INSURANCE INSTITUTE FOR HIGHWAY SAFETY

**Notice of Proposed Rulemaking
Federal Motor Vehicle Safety Standards; Side Impact Protection;
Side Impact Phase-In Reporting Requirements
Docket No. NHTSA-2004-17694**

Figure A-1 - Top and Side Cross-Sectional Views of FMVSS 214 (left) and IIHS (right) Barriers; All Measurements are in Millimeters

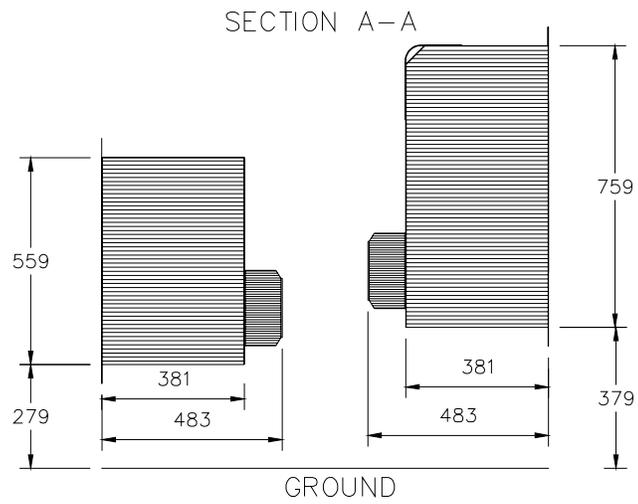
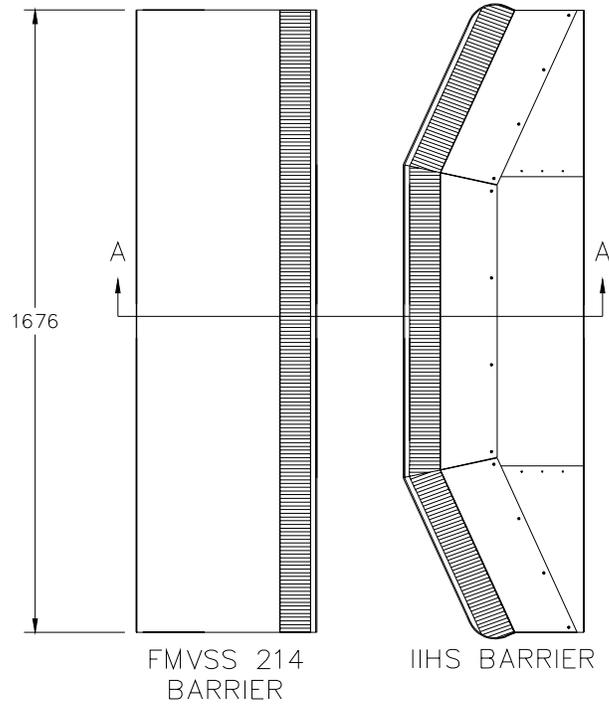
The IIHS barrier design is based on the FMVSS 214 barrier, but it is raised 10 cm from the ground and made 20 cm taller; this makes the IIHS barrier's top surface 30 cm higher than that of the FMVSS 214 barrier. The ride height of the IIHS barrier's bumper element is aligned closely with the lower edges of SUV and pickup bumpers measured at the time the IIHS barrier was designed (Arbelaez et al., 2002a). In addition to the changes made to the side view of the IIHS barrier, the front profile was contoured in the overhead view with simple 24.5-degree chamfers to represent the curved bumper geometry observed in the SUVs and pickups. A side-by-side illustration of the FMVSS 214 and IIHS barriers is shown in Appendix A, Figure A-1.

Because of this widespread acceptance and because the IIHS barrier better reflects the types of vehicles increasingly likely to cause serious injury in side impact collisions, we urge the agency to replace the now long out-of-date NHTSA MDB with the IIHS barrier for this rule. Rarely does such an opportunity for harmonized advancement of vehicle testing standards present itself. If the agency does not take this opportunity to improve the barrier and if it decides to accept less biofidelic dummy options (discussed next), it is difficult to see what benefits will accrue from the additional MDB tests that have been proposed.
